[TDL #510 from D2.0](#) - Response to David Stover regarding comment #510 D2.0
Addresses Comments on D2.1: #51, #164, #222.

D2.1 Table 33-19 item 22 page 116 line 37.

Figure 1 – I_{unb} and I_{bias}

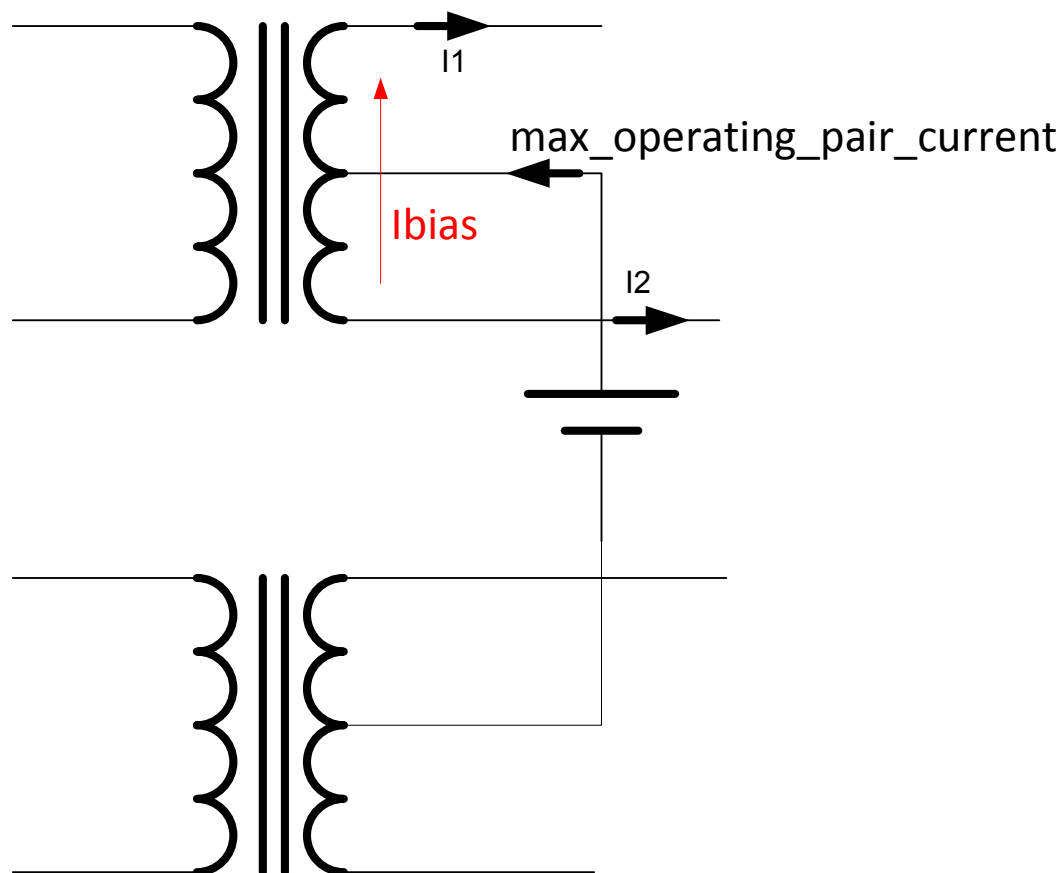
Not part of the baseline.	
Notes	
1	The transformer sees DC bias current which is a function of the current difference between the transformer outer legs: $I_{bias} = I_{unb} / 2 = 0.03 * 0.5 * \text{max_operating_pair_current}$. For 2-pair mode: $\text{max_operating_pair_current} = I_{peak}$. For 4-pair mode: $\text{max_operating_pair_current} = I_{peak} - 2P_{unb}$
2	We can't use absolute number for I_{unb} since it is Pclass dependent and cost optimization considerations requires keep it as $0.03 * \text{max_operating_pair_current} = 0.03 * I_{peak} - 2P_{unb}$ i.e. not the same I_{bias} in abs mA or I_{unb} in abs mA for every transformer.

$$I_{unb} = |I_1 - I_2| = 3\% \times \text{Max_operating_pair_current}$$

$$I_{bias} = I_{unb} / 2$$
